Project/File: **Plano Road Subdivision (SUB07-00065, CAR07-00042, CUP07-00084, CFH07-00022)**
This application is for preliminary plat, annexation, rezone, and hillside permit for 154 single-family homes on approximately 333 acres.

Lead Agency: City of Boise

Commission Hearing: April 23, 2008

Tech Review: April 11, 2008

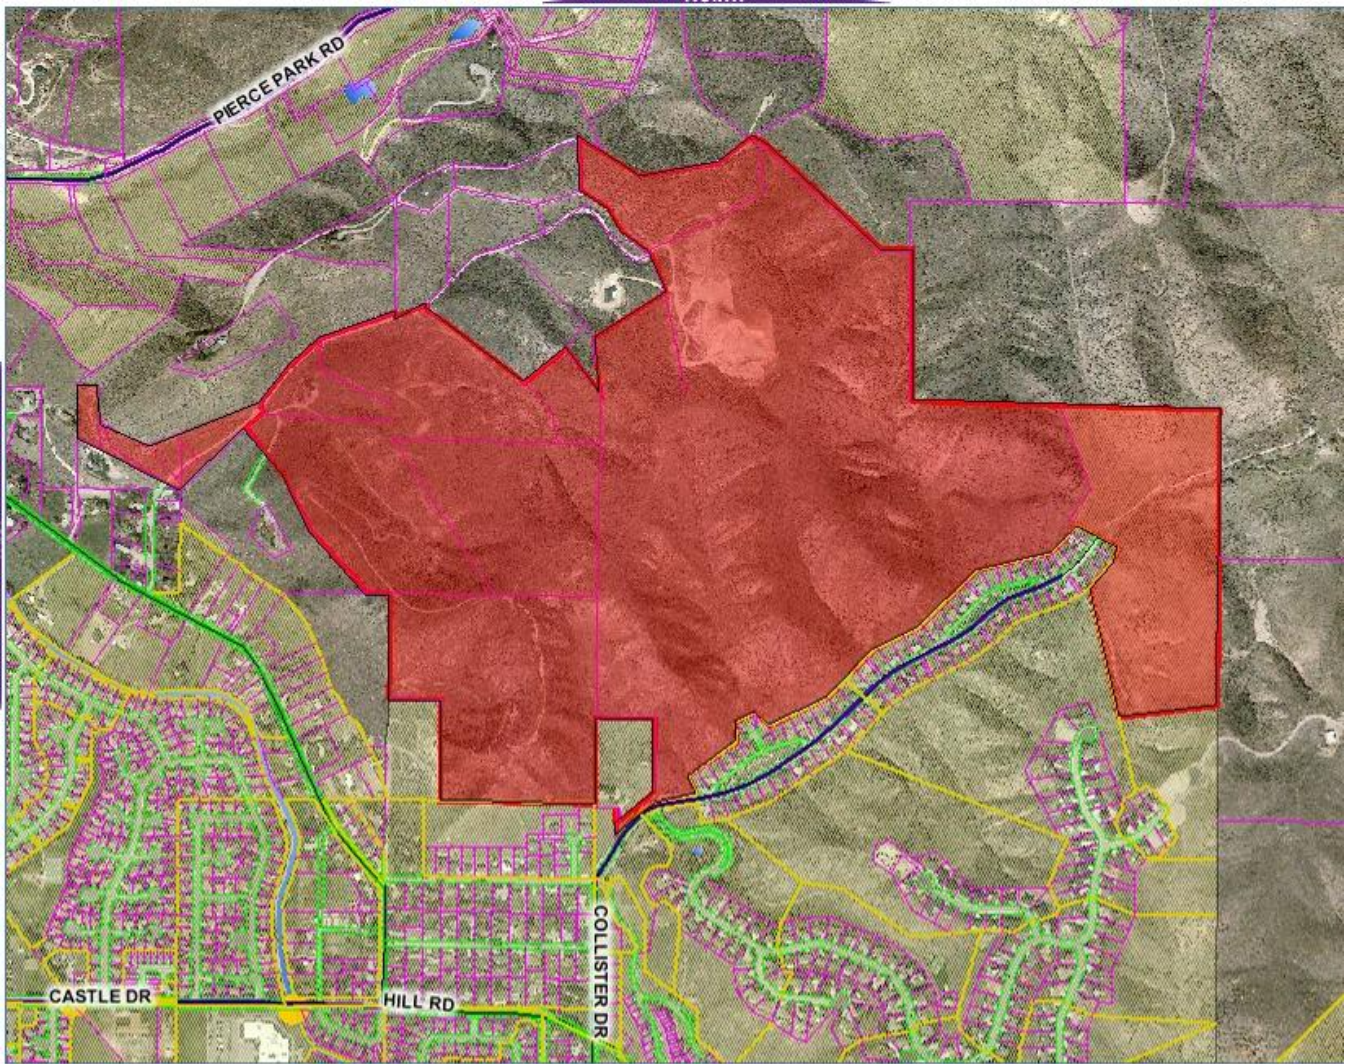
Staff Comment/Recommendation: The topography of the site presents a challenge in ensuring compliance with District policy 7204.4 for local street design. The applicant's current plans propose five curves with centerline radii less than 100-feet (two on Daylight Rim Drive, three on Dawnbreak Place), and one set of reverse curves with a tangent length of less than 50-feet between them (on Daylight Rim Drive). The applicant will likely also need a variance for a centerline curve radius of less than 100-feet if it is to be a continuous public street as recommended.

District staff recommends a modification of policy to allow the five curves with centerline radii less than 100-feet, the one centerline tangent length between reverse curves of less than 50-feet, provided all internal roadways meet AASHTO standards for a 20 MPH design speed. District staff recommends against any modification of policy to allow any centerline grade in excess of 10%.

14. Ensure that all street geometries comply with District policies 7204.4.8 through 7204.4.13, except where a modification of policy has been granted. Modification of policy has been granted for only the following:

- a. Centerline radius of 86-feet at Sta. 11+50 to 14+50 of Daylight Rim Drive.
 - b. Centerline radius of 86-feet at Sta. 19+00 to 22+00 of Daylight Rim Drive.

- c. Centerline radius of 86-feet at Sta. 305+50 to 307+00 of Buck Hollow Way.
 - d. Centerline radius of 86-feet at Sta. 314+25 to 315+50 of Buck Hollow Way.

- e. Centerline radius of 86-feet at Sta. 316+00 to 317+25 of Buck Hollow Way.
 - f. Centerline tangent length between curves of less than 50-feet at Sta. 22+21.16 of Daylight Rim Drive.
